ORE - TRAFFIC: January 2026 Proposed SDMM Updates Summary

STANDARD SIGN DESIGN

ODOT - OFFICE OF TRAFFIC OPERATIONS

CODE NO.: M8-H4n

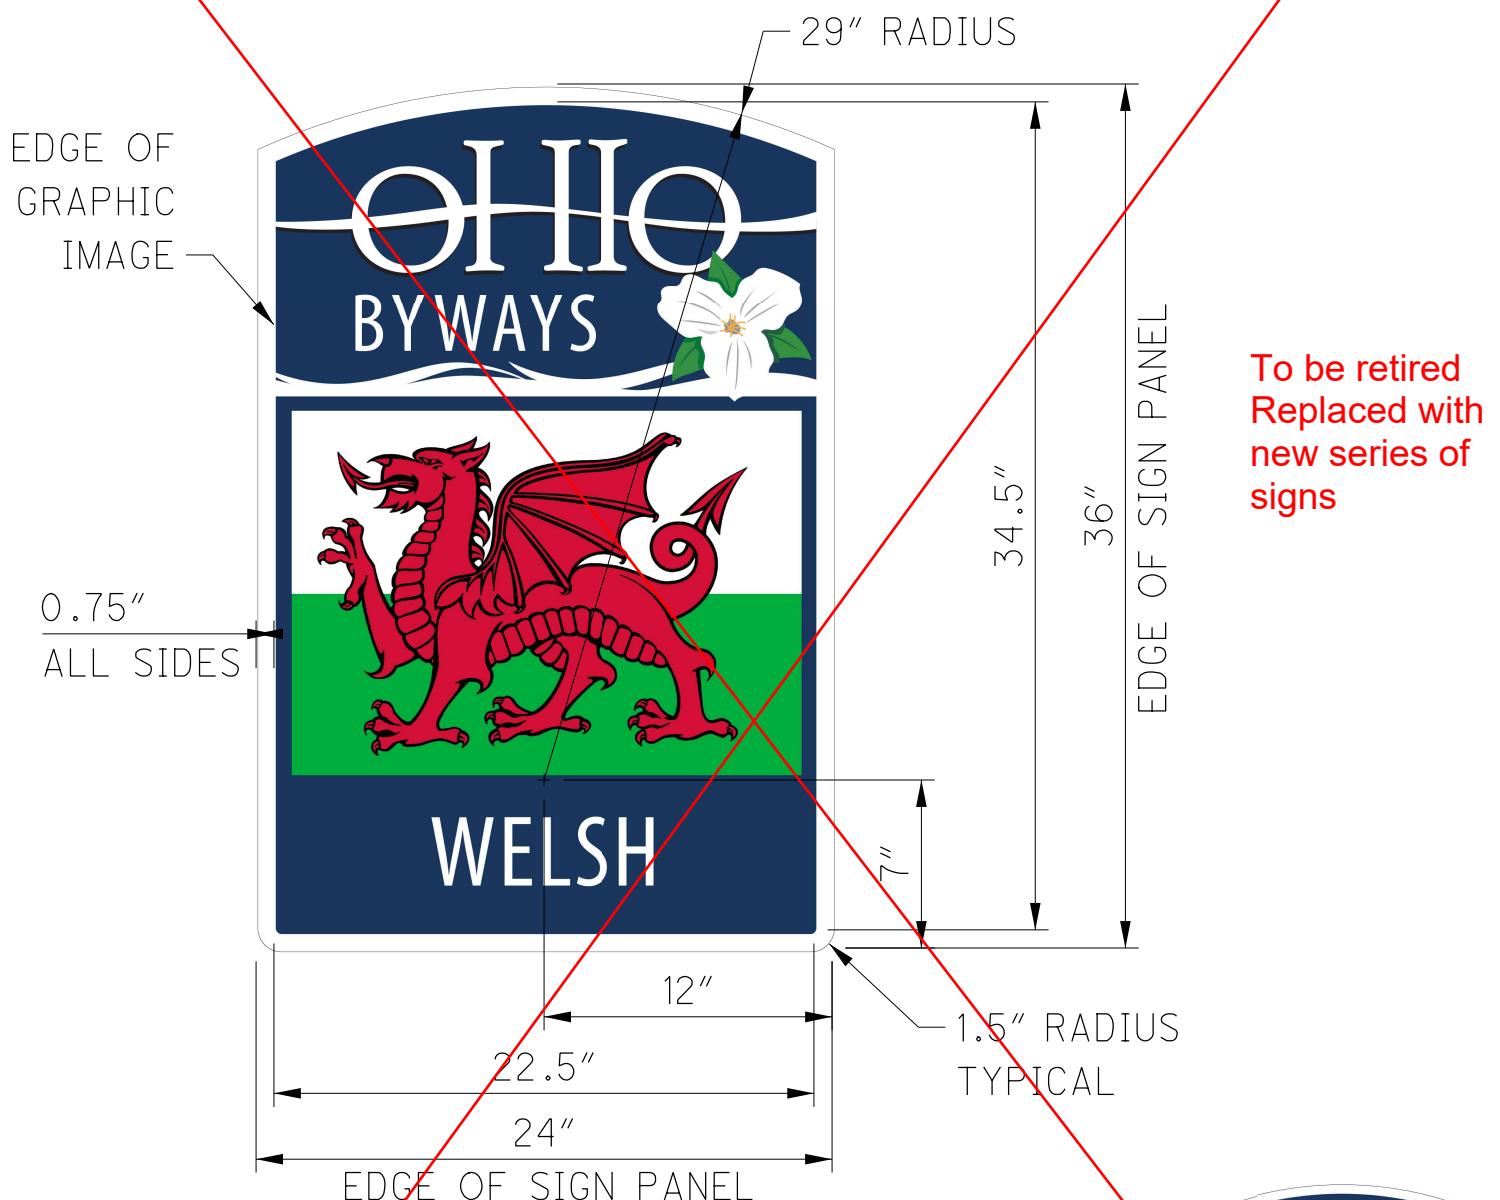
| Revision Type | Reference | Section Description (Red indicates Change of name from existing) | Description of Revision | New or Deletion | Primary POC |
|---------------|-----------|-------------------------------------------------------------------------------------------|---------------------------------------------------------------------------------------------------------------------------------------------------------------------|-----------------|-------------|
| SDMM | M8-H4n | Ohio Byway - Welsh Scenic Byway | Retiring existing sign. Being replaced by M10-H3an | Deletion | Soisson |

CODE NO.: M8-H4q

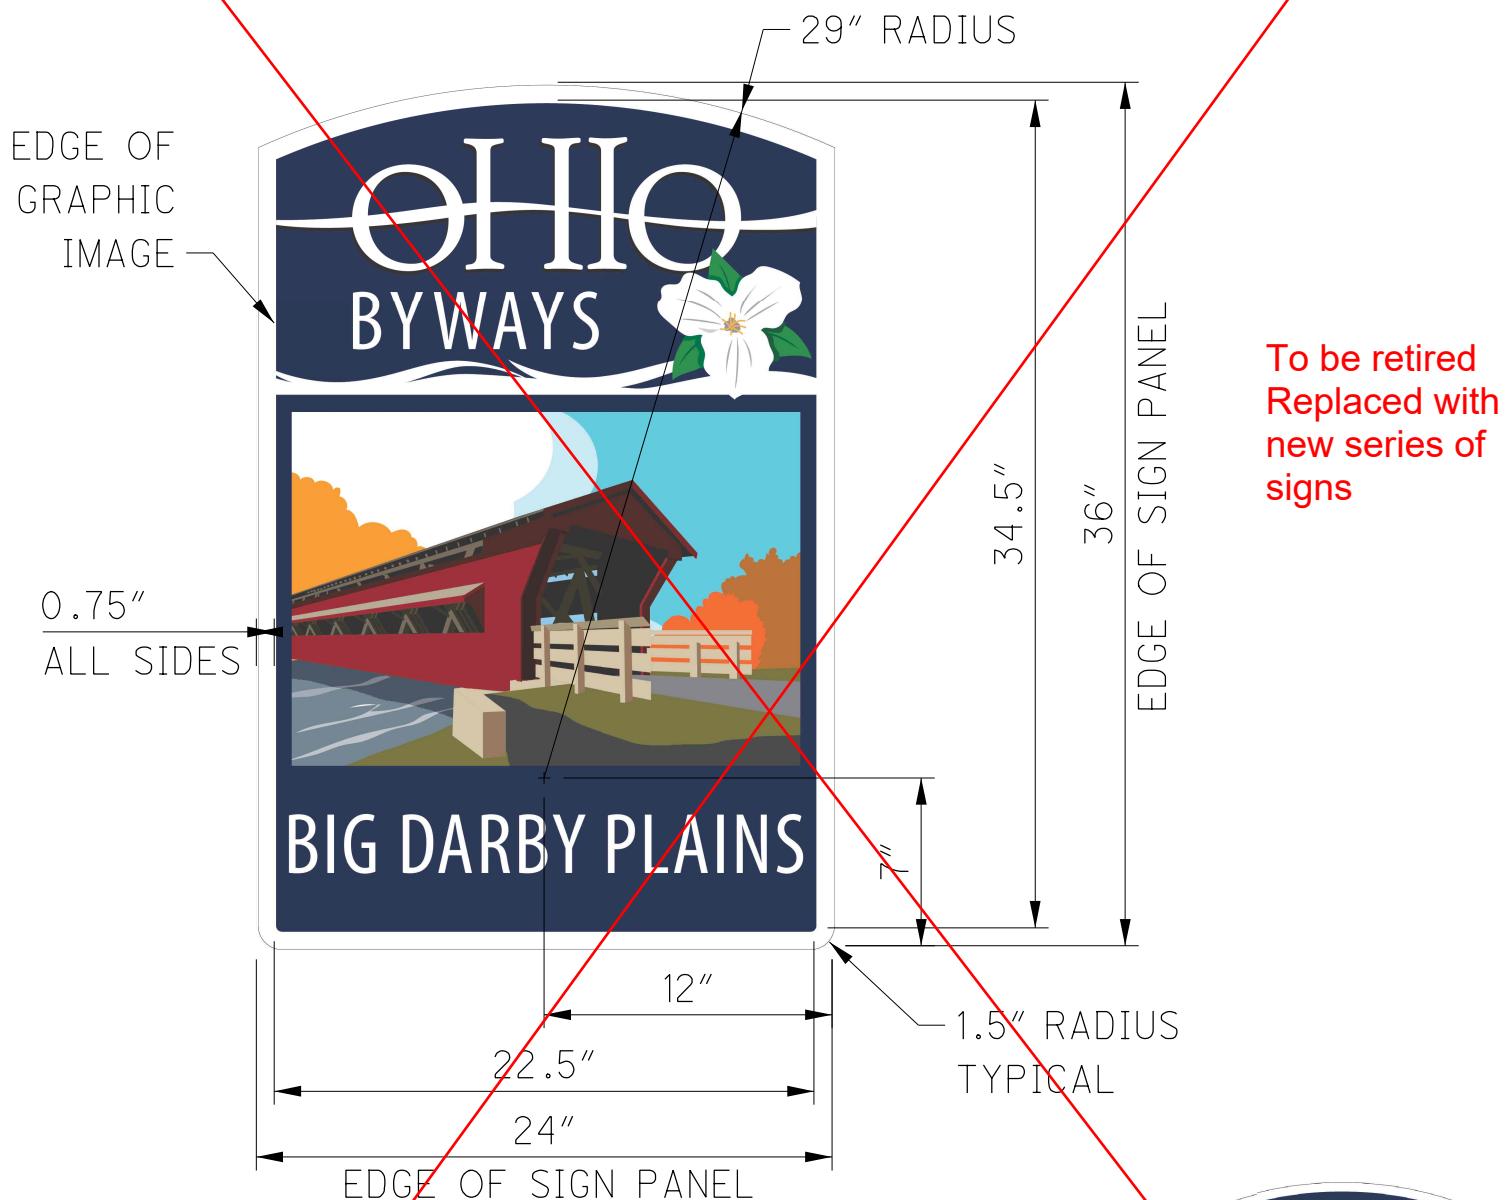
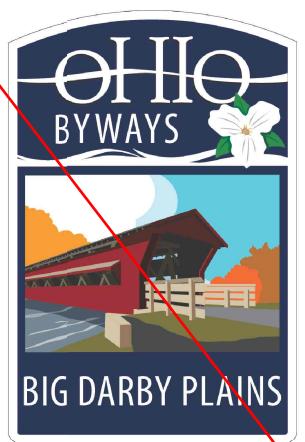
| Revision Type | Reference | Section Description (Red indicates Change of name from existing) | Description of Revision | New or Deletion | Primary POC |
|---------------|-----------|-------------------------------------------------------------------------------------------|---------------------------------------------------------------------------------------------------------------------------------------------------------------------|-----------------|-------------|
| SDMM | M8-H4q | Ohio Byway - Big Darby Plains Scenic Byway | Retiring existing sign. Being replaced by M10-H3aq | Deletion | Soisson |

CODE NO.: M8-H4s

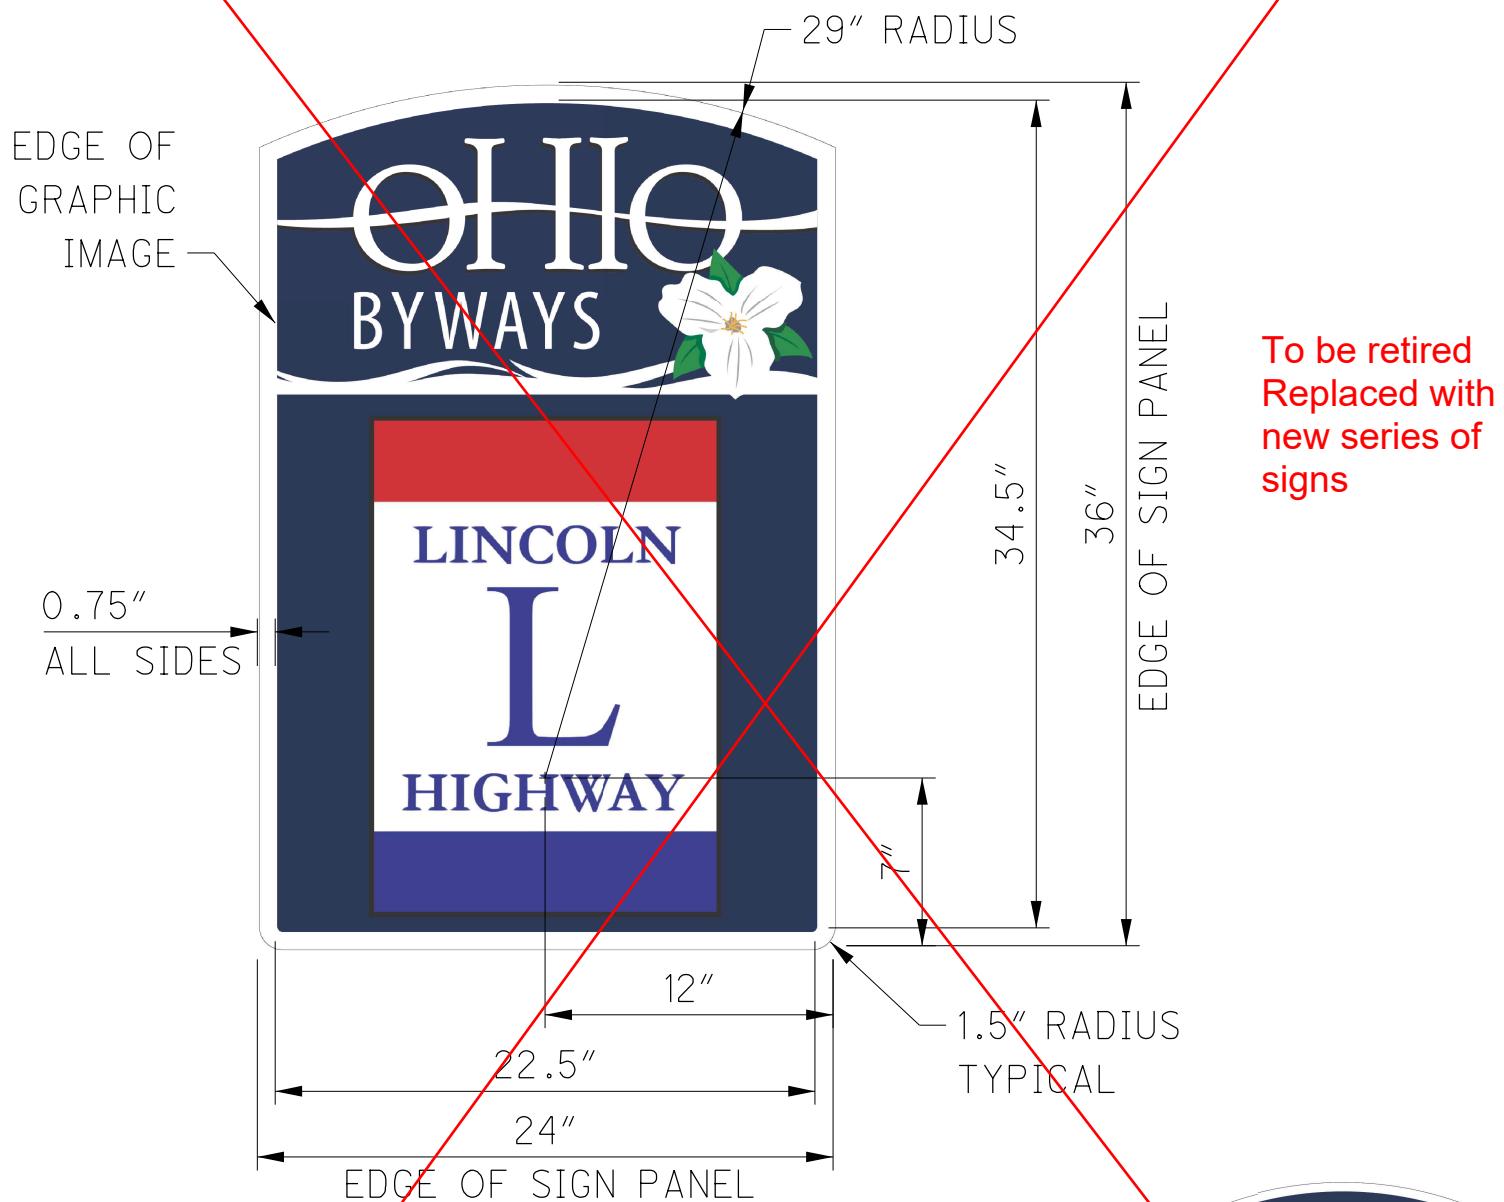
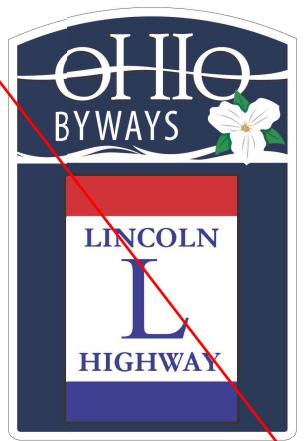
| Revision Type | Reference | Section Description (Red indicates Change of name from existing) | Description of Revision | New or Deletion | Primary POC |
|---------------|-----------|-------------------------------------------------------------------------------------------|---------------------------------------------------------------------------------------------------------------------------------------------------------------------|-----------------|-------------|
| SDMM | M8-H4s | Ohio Byway - Lincoln Highway Historic Byway | Retiring existing sign. Being replaced by M10-H3as | Deletion | Soisson |

CODE NO.: M8-H4†

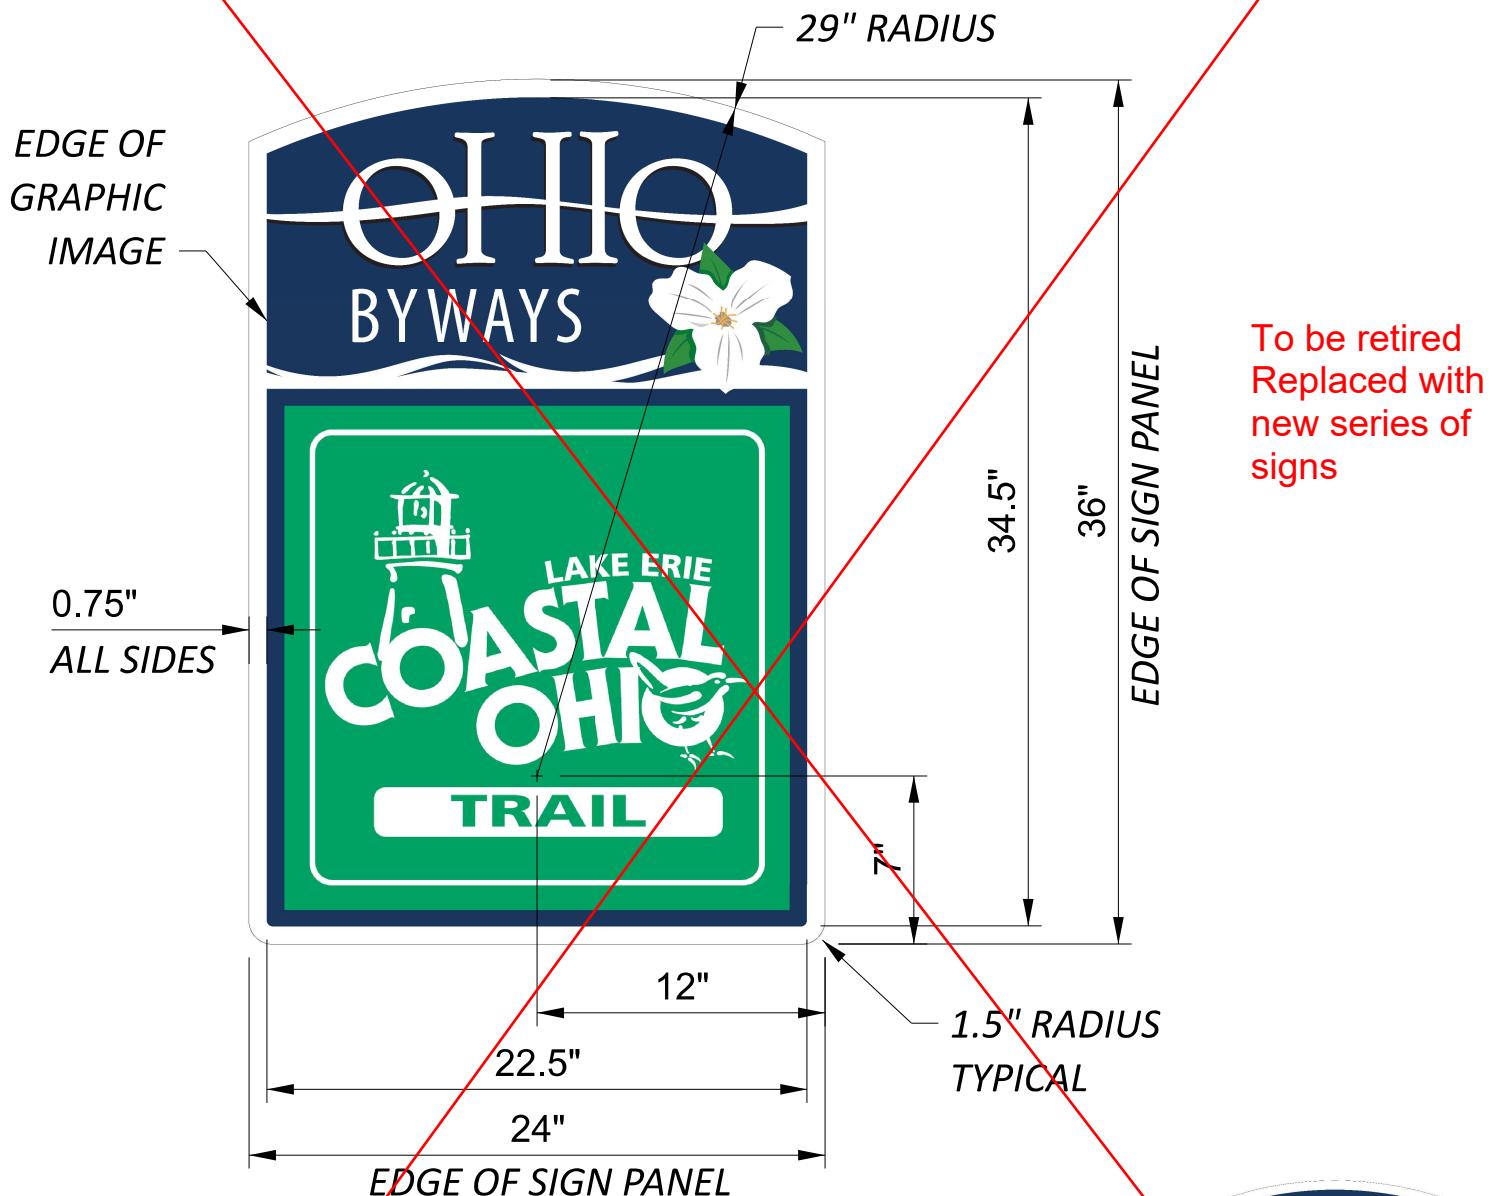
| Revision Type | Reference | Section Description (Red indicates Change of name from existing) | Description of Revision | New or Deletion | Primary POC |
|---------------|-----------|-------------------------------------------------------------------------------------------|---------------------------------------------------------------------------------------------------------------------------------------------------------------------|-----------------|-------------|
| SDMM | M8-H4t | Ohio Byway - Lake Erie Coastal Ohio Trail | Retiring existing sign. Being replaced by M10-H3at | Deletion | Soisson |

CODE NO.: M8-H4w

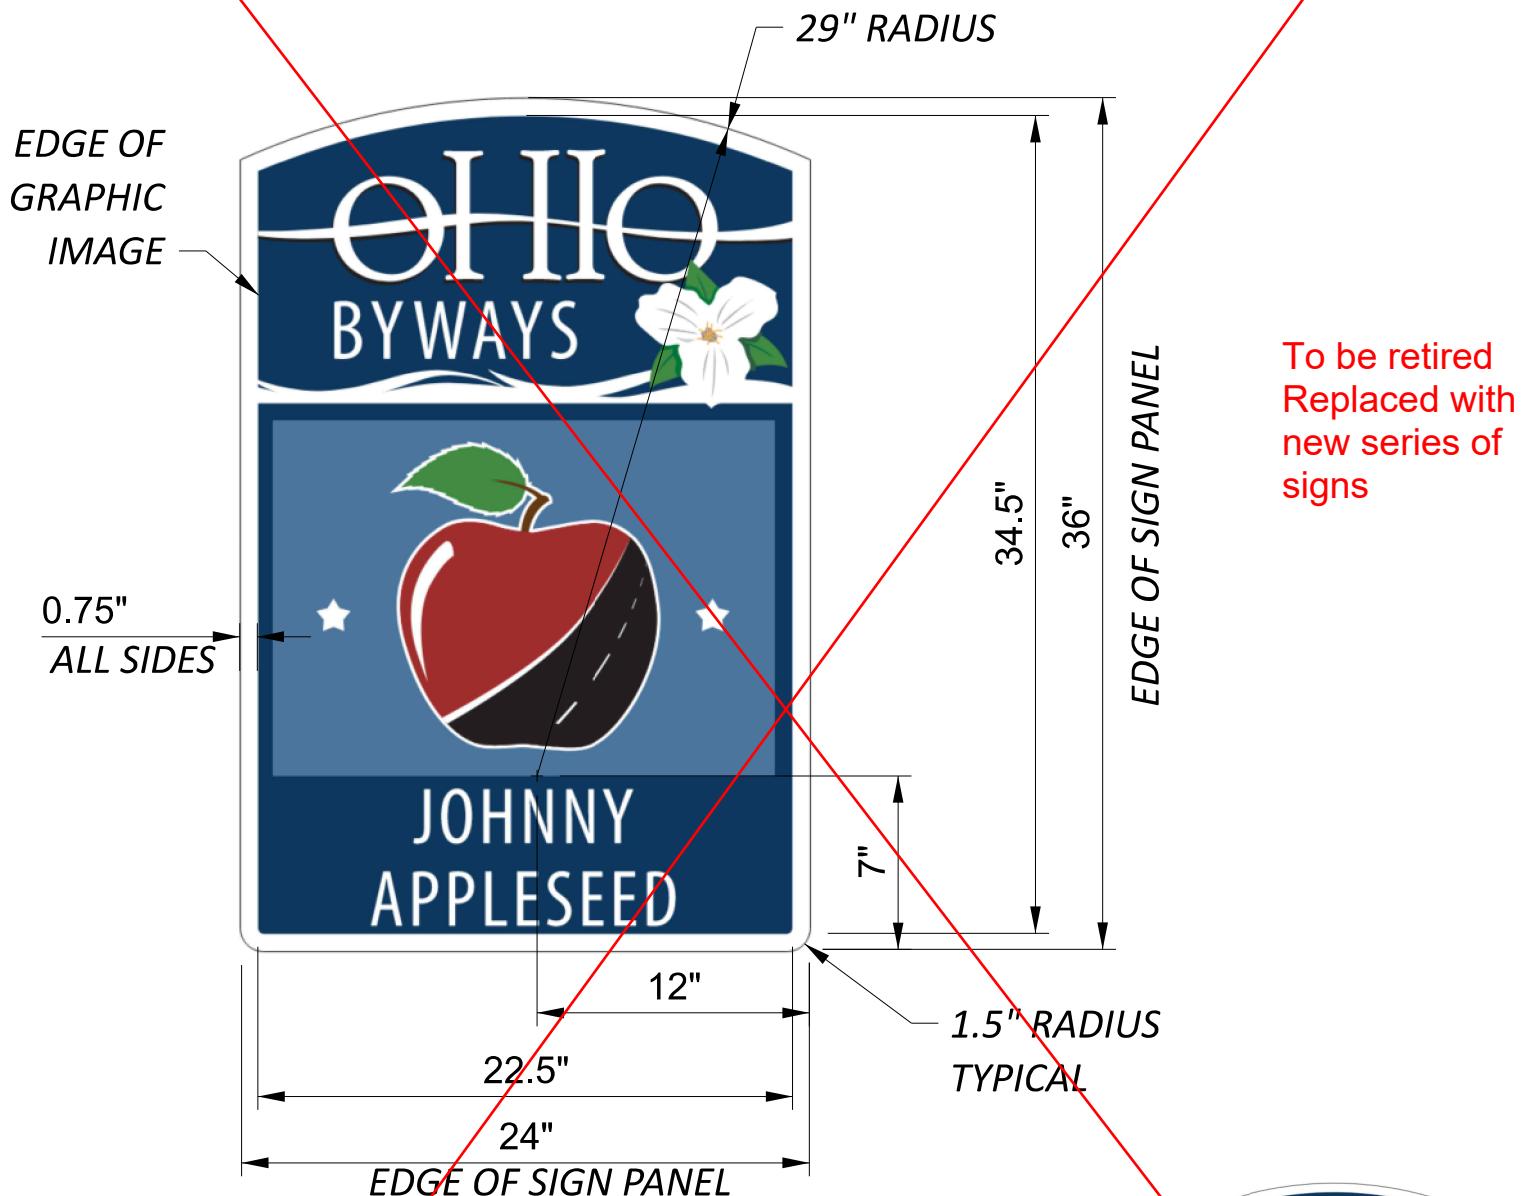
| Revision Type | Reference | Section Description (Red indicates Change of name from existing) | Description of Revision | New or Deletion | Primary POC |
|---------------|-----------|-------------------------------------------------------------------------------------------|---------------------------------------------------------------------------------------------------------------------------------------------------------------------|-----------------|-------------|
| SDMM | M8-H4w | Ohio Byway - Johnny Appleseed Historic Byway | Retiring existing sign. Being replaced by M10-H3aw | Deletion | Soisson |

Added July 2025

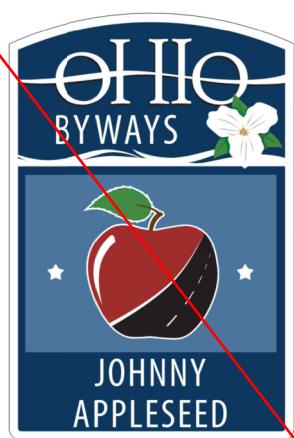
Sign Dimensions
and Details to be
similar to Heritage
Corridors of Bath
Sign approved with
July 2025 updates

CODE NO.: R13-H1

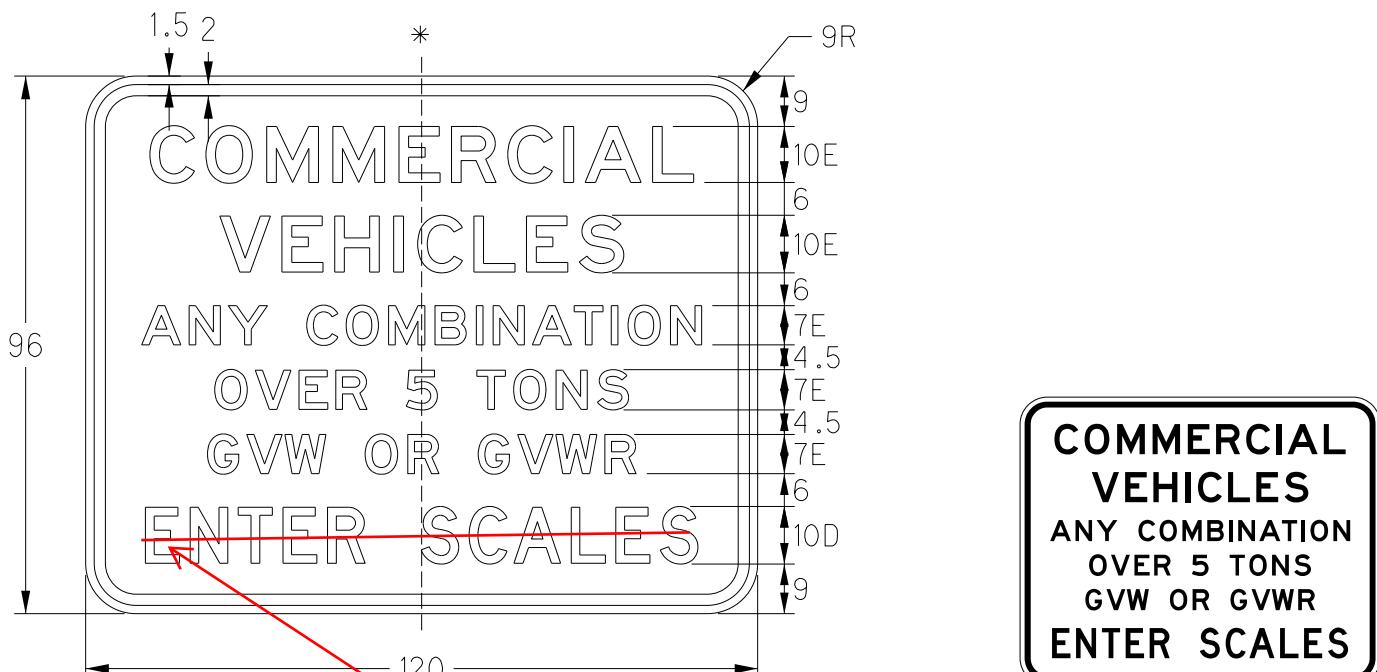
| Revision Type | Reference | Section Description (Red indicates Change of name from existing) | Description of Revision | New or Deletion | Primary POC |
|---------------|-----------|-------------------------------------------------------------------------------------------|---------------------------------------------------------------------------------------------------------------------------------------------------------------------|-----------------|-------------|
| SDMM | R13-H1 | COMMERCIAL VEHICLES ANY COMBINATION... | Change ENTER SCALES to MUST ENTER WEIGH STATION | | Eberhardt |

"MUST ENTER
WEIGH STATION"

Engineering Reason
for Change: Aligning
with the MUTCD
